**PLANNED UNIT DEVELOPMENT  
& SUBDIVISION STAFF REPORT****Date: April 3, 2014****DEVELOPMENT NAME**

First Baptist Church of Tillman's Corner Subdivision

Planned Unit Development to allow multiple buildings on a single building site and Subdivision approval to combine multiple lots to create one legal lot of record.

# DEMOLITION PLAN

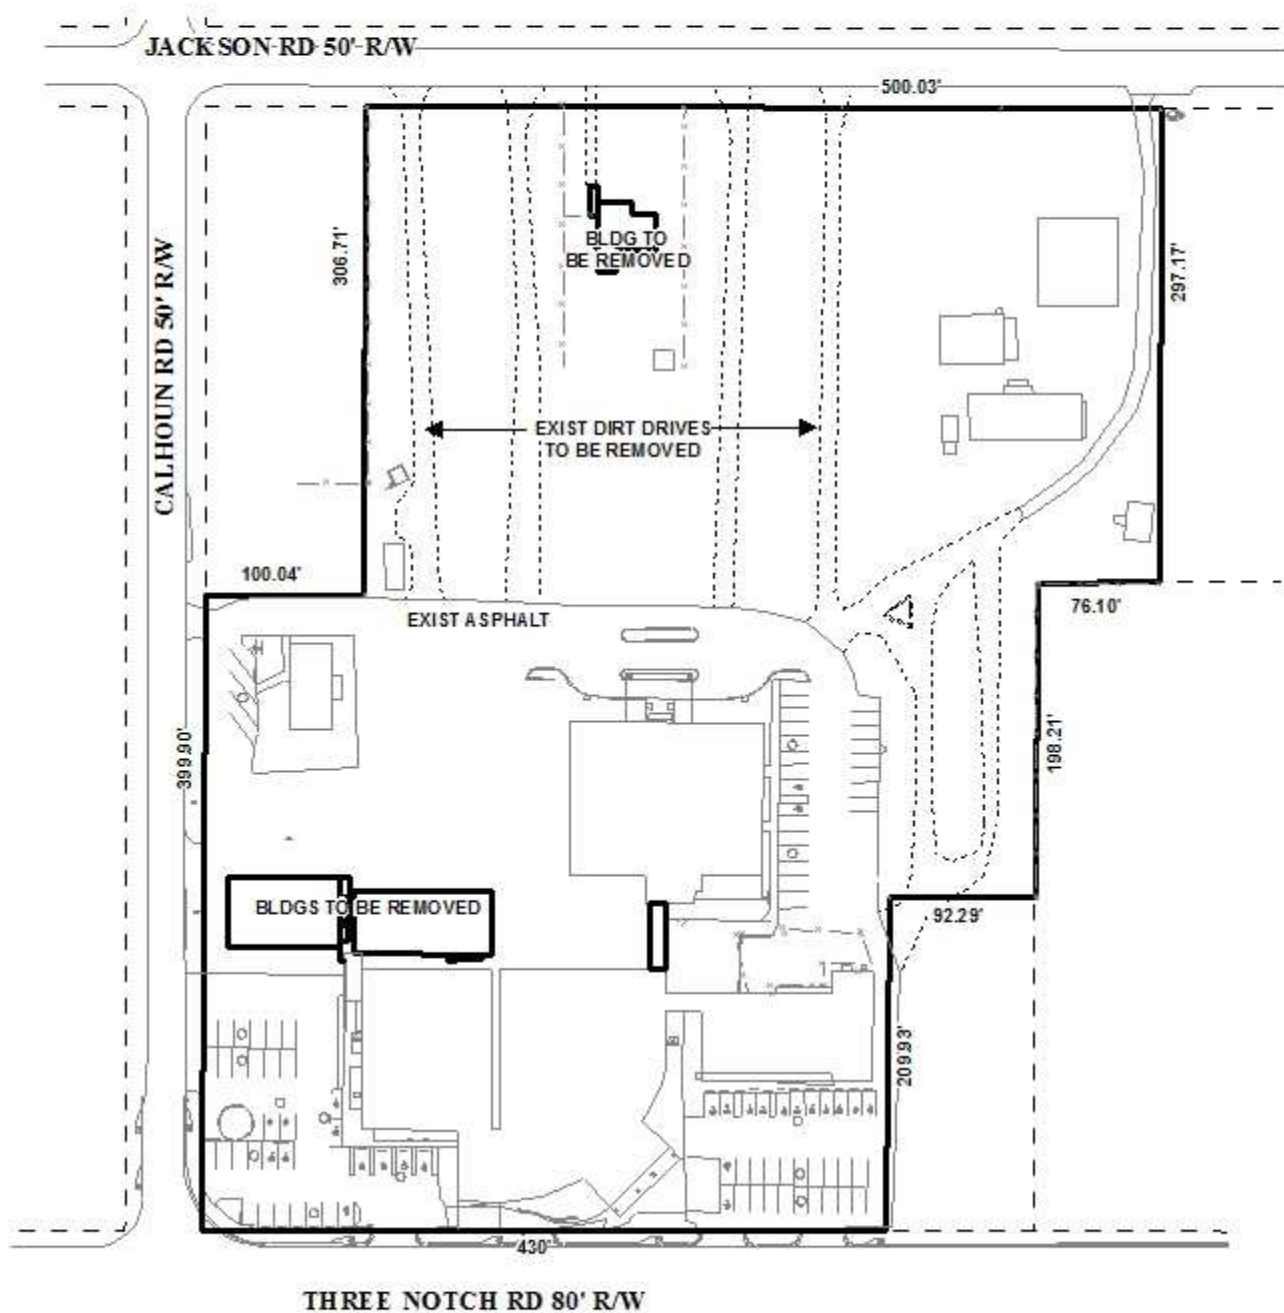
Access management is a concern due to the site's fronting 3 streets with multiple curb-cuts and existing substandard vehicle maneuverability areas. The site has 13 existing curb-cuts and as the applicant proposes to improve access, 10 curb-cuts will still remain. The southern lot line, which runs along Three Notch Road, has 4 curb-cuts and the western lot line along Calhoun Road has 3 curb-cuts, one of which appears to be over 75' ± wide. The curb-cuts access existing and proposed parking area. It should be pointed out that some of the existing travel aisles measure only 9' ± and, as such, Staff recommends a one-way traffic circulation if the existing parking

areas are remain non-compliant. Jackson Road has 6 existing, substandard curb-cuts. The applicant proposes to eliminate 3 and retain and improve 2 of the curb-cuts. As one of the gravel drives appears to remain unimproved, the site plan should be revised to illustrate a paved drive.

The site plan illustrates several existing issues within the site. A portion of the eastern property line north of Three Notch Road appears to share access with the adjacent lot to the east, which is not included in this request. The site plan should be revised to illustrate curbing and landscaping along the eastern property line to prevent vehicular access between the two lots. If the applicant desires to continue a shared access, the lot to the east should be included in the PUD request.

All proposed parking areas appear to be compliant in terms of travel aisle width and parking stall dimensions; however, the site plan does not depict any proposed lighting. Any new lighting on the site will have to comply with the requirements of Sections 64-4.A.2., 64-6.A.3.c., and 64-6.A.8. of the Zoning Ordinance. A note reflecting this requirement should appear on the site plan, and photometric plans will be required at the time of permitting.

It should be pointed out that the site plan does not depict any sidewalks along any street frontages. The site plan should be revised to illustrate sidewalks along all street frontages or the applicant should submit a Sidewalk Waiver request.

Also, the site plan does not depict a residential buffer nor frontage trees and landscaping. A 10' residential buffer should be required along the northwestern lot line where the property abuts an

adjacent residentially developed lot and along the northeastern lot line where the property abuts a vacant lot which may be developed residentially. The site plan should be revised to illustrate the buffer in compliance with Section 64-4.D.1. of the Zoning Ordinance and illustrate and quantify full compliance with the tree and landscaping requirements of Section 64-4.E. of the Zoning Ordinance.

The site plan depicts a dumpster and it should be noted that all dumpsters shall be in compliance with Section 64-4.D.9. of the Zoning Ordinance to include being enclosed on at least three sides and connected to sanitary sewer.

- 1) Provision of a written statement that the owner will petition for inclusion or exclusion from the city;
- 2) Revision of the site plan to depict a permanent closure of the vehicular access to the adjacent property to the east with curb and landscaping, or the revision of the PUD request to include the lot to the east and shared access;

- 3) Revision of the site plan to comply with Traffic Engineering Comments: (*Driveway number, size, location and design to be approved by Traffic Engineering and conform to AASHTO standards. The southern most driveway on Calhoun Road must be reduced in width, by maintaining the proposed northern radii and moving the southern radii to match the adjacent aisle width. All new on-site parking, including ADA handicap spaces, shall meet the minimum standards as defined in Section 64-6 of the City's Zoning Ordinance.*);

- 4) Coordination with Staff to improve onsite traffic flow and revision of the site plan to illustrate one-way traffic flow with compliant 12' travel aisles/vehicular maneuverability area where travel aisles are less than 24';

- 5) Revision of the site plan to illustrate proposed lighting along with a note stating any new lighting on the site will have to comply with the requirements of Sections 64-4.A.2., 64-6.A.3.c., and 64-6.A.8. of the Zoning Ordinance;

- 6) Depiction of a paved driveway in the northeast corner of the lot if the applicant desires to retain the curb-cut;
- 7) Depiction of sidewalks on the site plan along all street frontages or the submission of a Sidewalk Waiver request;

- 8) Depiction of a 10' residential buffer on the site plan along the northeastern and northwestern lot lines in compliance with Section 64-4.D.1. of the Zoning Ordinance;

- 9) Revision of the site plan to illustrate and quantify full compliance with the tree and landscaping requirements of Section 64-4.E. of the Zoning Ordinance;

- 10) Revision of the site plan to include a note stating that all common and detention areas shall be maintained by the property owners;
- 11) Revision of the site plan to reflect sufficient dedication to provide 30' as measured from the centerline of both Calhoun and Jackson Roads;

- 12) Revision of the site plan to depict a corner radius in compliance with Section V.D.6. of the Subdivision at the intersection of Calhoun and Three Notch Roads;

- 13) Revision of the 25' minimum building setback line on the site plan to reflect dedication and corner radius;
- 14) Revision of the site plan to depict a 35' minimum building setback line along Three Notch Road; and

- 15) Depiction of a dumpster on the site plan in compliance with Section 64-4.D.9. of the Zoning Ordinance.
